Appln. No.: 10/522,044
Amendment Dated April 12, 2007
Reply to Office Action of January 24, 2007

Amendments to the Drawings:

Remarks/Arguments:

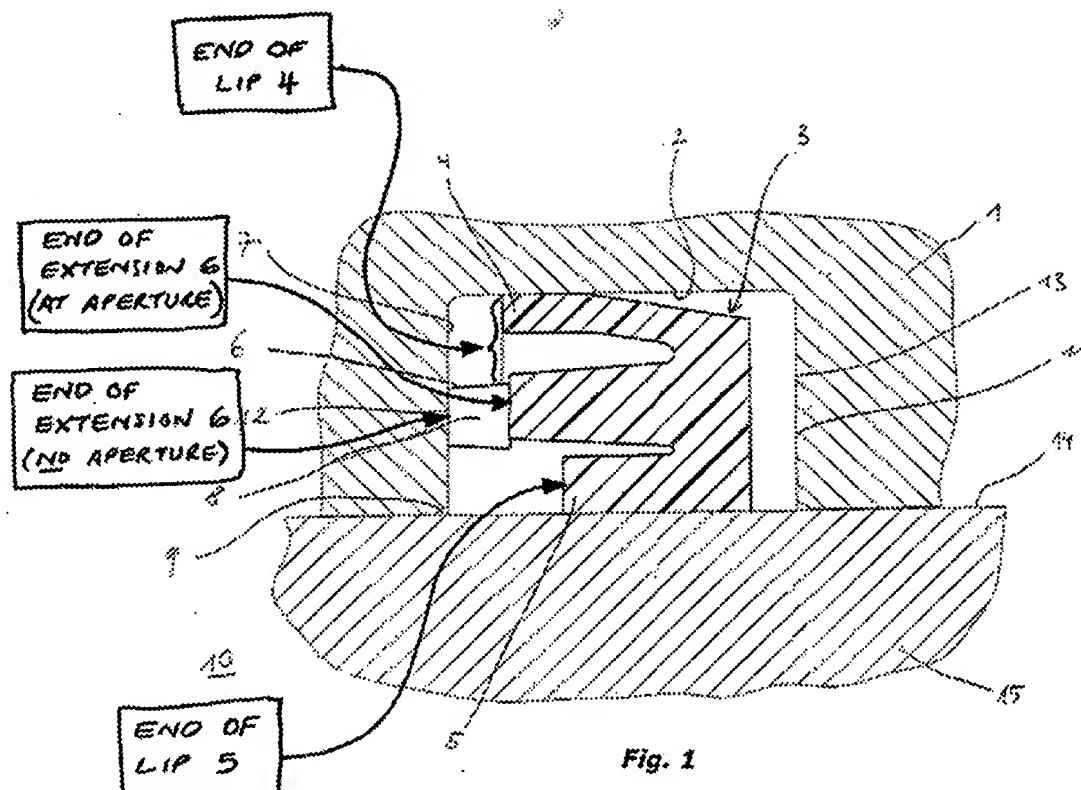
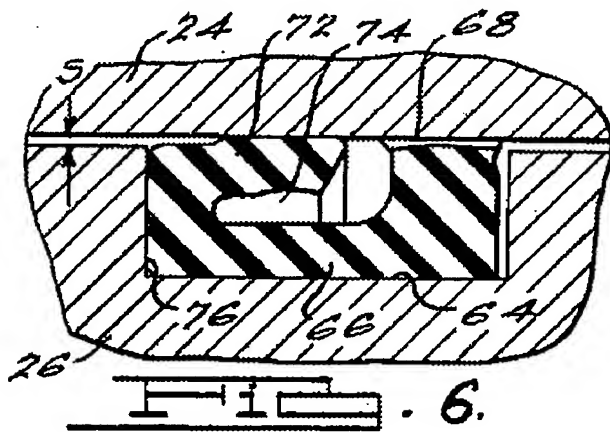
Claims 15-26 are pending in the application. In the Office Action dated January 24, 2007 ("Office Action"), Applicant's Figure 1 was considered objectionable under 37 C.F.R. § 1.121. The specification was also considered objectionable for allegedly introducing new matter. Claim 21 was considered insufficient to meet the written description requirement under 35 U.S.C. § 112, first paragraph. Claims 15-26 were considered indefinite under 35 U.S.C. § 112, second paragraph. Lastly, claims 15-20 and 22-26 were considered anticipated by U.S. Patent No. 4,602,791 ("Zollner") under 35 U.S.C. § 102(b).

Figure 1 is objected to based on an apparent misunderstanding of the three-dimensional view and circular geometry depicted in the drawing. Applicant respectfully submits that the features are clear and should require no additional explanation. To further prosecution, Applicant has amended the specification and drawing to identify the vertical extension line extending from circumferential lip 4, which represents the free end of the lip visible behind the plane where the section is taken. For added explanation, Applicant is reproducing the prior version of Figure 1 with appropriate labeling below:

Q: "It is unclear as to how 8 corresponds to the extension because it is off center."

Q: "It is also unclear as to where the extension ends because the aperture labeled as 8 is off-centered from the extension"

Q: It is also unclear as to what the extra line connecting the outside lip 4 and the aperture 8 in Fig. 1 is for, the line must be identified . . . or the line must be removed

The Office Action finds that it is unclear whether there is a circular geometry depicted for extension 6 in Fig. 1.

Please replace the drawing sheet containing Fig. 1 with the attached replacement drawing sheet (now Sheet 1 of 1).

The above figure identifies the free ends of the lips 4, 5 and the free end of the extension 6. The free ends of lips 4, 5 are labeled 40 and 50, respectively, in the corrected drawing sheet. Free end 12 of extension 6 is already labeled. Note that free end 12 of extension 6 does not contact the groove wall 7 in the cross-sectional plane, because of the aperture. In planes beyond the cross-section, the aperture ends, and free end 12 becomes contiguous with groove wall 7.

A: Reference number 8 refers to the aperture, not the extension 6 (see specification).

A: The location of the free end of the extension 6 depends on the cross-section. At sections containing an aperture, the extension 6 ends short of the groove wall 7. At sections that do not contain an aperture, the extension 6 ends contiguous with the groove wall 7. The aperture is not "off-centered" from the extension. The aspect that appears to be off-centered is a plane where the groove ends. Sealing collar 3 has a circular geometry, and the extension 6 and lips 4, 5 turn through a radius to follow the circular geometry. Therefore, one skilled in the art who views the sealing collar in cross section will expect there to be some angular offset in the drawing to show the cross-sectional plane, and other planes that are visible beyond the cross-sectional plane. The plane where the aperture 8 ends is not "off-centered", but rather angularly offset from the plane through the cross-section. The staggered shape represents the plane where the aperture ends, and where the non-apertured portion of extension 6 begins.

A: The line that appears to connect lip 4 and extension 6 represents the free end of lip 4. This free end is now labeled in the drawing and described in the specification as free end 40. It is shown as an "extension line" to reflect that the free end 40 makes a continuous turn as it extends in a circular manner. Omitting this line would be misleading because the lip 4 would no longer be depicted as a circumferential lip that extends continuously through the radius.

Applicant has amended the specification to identify free ends 40, 50 of the outer lip 4 and inner lip 5, respectively. The specification makes multiple references to the free ends of the lips. Therefore, no new matter has been added.

This statement ignores the entire contents of the specification. The specification clearly states: "The extension indicated hereinabove as being circumferential will then be decomposed into single extensions being placed on a circumferential **circle**" (Spec., p.5 lines 1-5). The subject matter is a sealing **collar**, which is commonly understood to be a circular ring. The sealing collar is described in a **cylinder** and piston unit. Cylinders have circular cross sections. The extension is described as "**circumferential**" and positioned "**radially** between" first and second sealing lips (p. 3 lines 9-13). The circular shape of the extension is clear.

The Office Action can not review a drawing in a vacuum. The drawing must be reviewed in conjunction with the written description. If there is any doubt about what a drawing conveys, the analysis must at least consider what the specifications says about the drawing. In the instant matter, Applicant respectfully submits that the objections and rejections which express doubts about the shape of the extension 6 are unfounded.
